SITE PLAN
LOT: #2
BLK: #10
GRANDVIEW HEIGHTS

STANDARD REQUIREMENTS FOR DRAINAGE PLANS

CHECK LIST

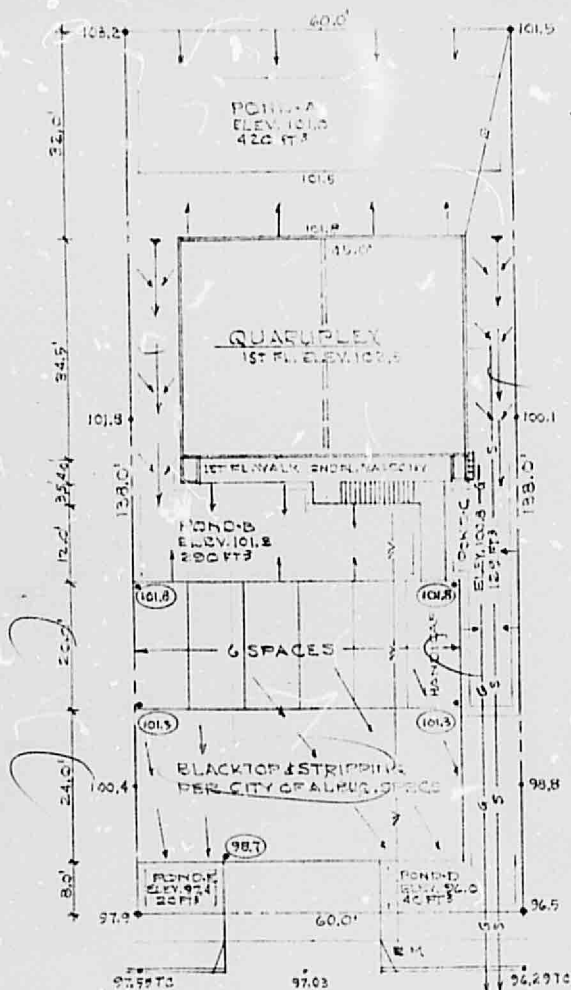
no Is property located in the flood plain? *J22 FNDM 18,25*

no Is property adjacent to a natural or artificial water course?

no Are drainage R.O.W. or easements shown on, or in the proximity of property? If so are there drainage problems?

no Per topo map, does property intercept other drainage upstream?

no Does site plan show contours before development (extending a minimum of 25 ft. beyond property lines)?

yes Does site plan show proposed grading with adequate swale definition to convey water to ponds?

yes Is all runoff conveyed to ponding areas before it overflows to public facilities?

yes Is elevation of property line at least 0.3 ft. above top of curb?

yes Is ponding volume adequate (supply detailed completion)? ^{station}

yes Are ponds balanced with areas they drain (can area draining to each pond be easily identified and will actually water flow there)? The plot plan must outline each drainage area.

yes Can pond volume be computed and verified?

yes Are ponds practical, can they be built as shown?
